BROWNS FERRY NUCLEAR PLANT (BFN) - UNITS 1, 2, AND 3 -  
LICENSE RENEWAL APPLICATION (LRA) - RESPONSE TO NRC REQUEST  
FOR CLARIFICATION FOR BFN'S USE OF LINDE 80 WELD MATERIAL ON  
UNIT 1 (TAC NOS. MC1704, MC1705, AND MC1706)

RESPONSE TO NRC REQUEST FOR CLARIFICATION FOR  
BROWNS FERRY USE OF LINDE 80 WELD MATERIAL ON UNIT 1

Figure 1

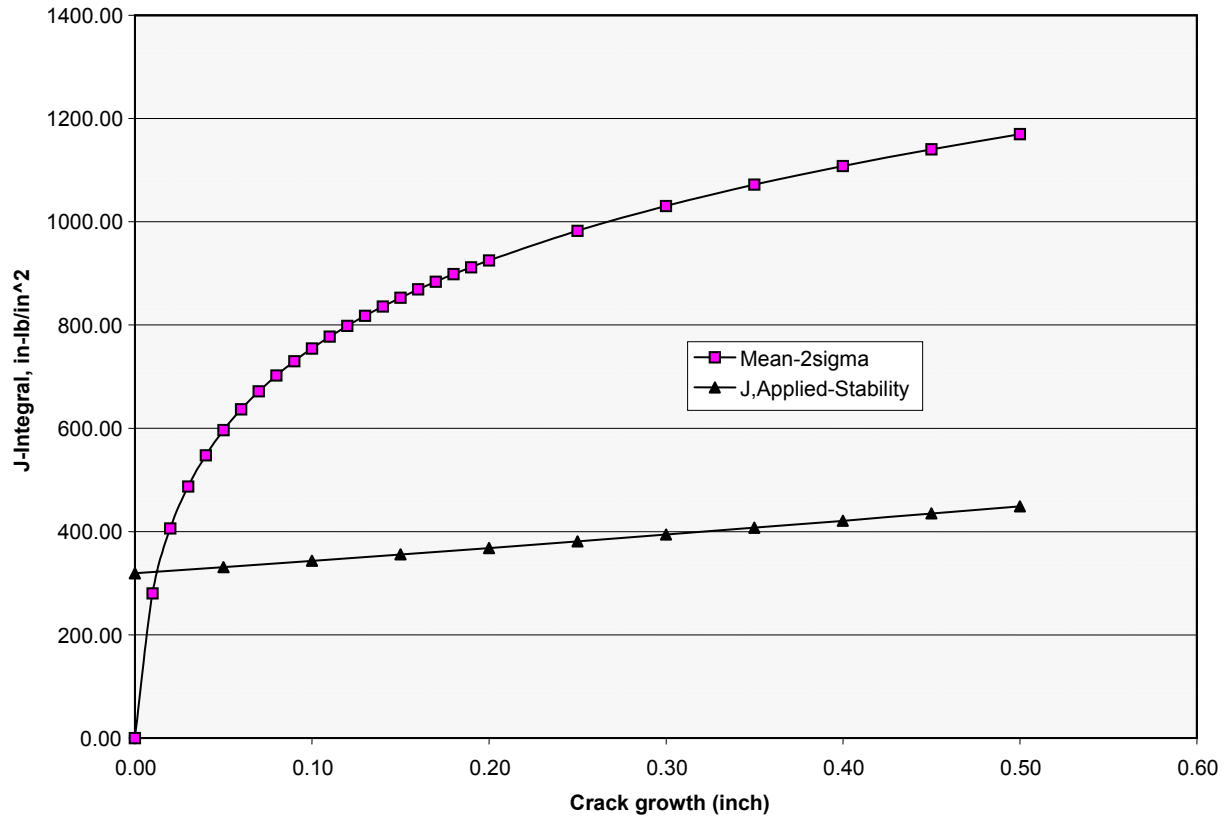
The limiting beltline circumferential weld - heat # 406L44 for BFN Unit 1 is made of Linde 80 material. According to Section B.3.4 of the BWRVIP-74, "BWR Reactor Pressure Vessel Inspection and Flaw Evaluation," report, fracture toughness of the weld shall be established by using J-R curve based on the values of copper and fluence. In the LRA, the applicant provided EMA for this weld by using figure 2 of the RegGuide 1.99 which is not appropriate for Linde 80 weld. Therefore, the staff requests that the applicant revise the Table 4.2.1.1 of the LRA to indicate that the EMA analysis for the circumferential Linde 80 weld in BFN Unit 1 complies with the requirements specified in Section B.3.4 of the BWRVIP-74 report, and submit any calculations to substantiate its claim of compliance with this method.

The remaining values of  $J_d$  were calculated in a similar manner, varying the crack growth value,  $\Delta a$ . The results of the calculations are presented in Figure 1.

To determine if the material maintains adequate fracture toughness, the  $J_{\text{applied}}$  values are also plotted in Figure 1; the  $J_{\text{applied}}$  values were obtained from Figure 5-5 of Reference 1. As can be seen in the figure, the  $J_{\text{applied}}$  values are shown to be well within the J-R curve limits. Therefore, BFN Heat 406L44 will maintain adequate fracture toughness throughout the period of extended operation.
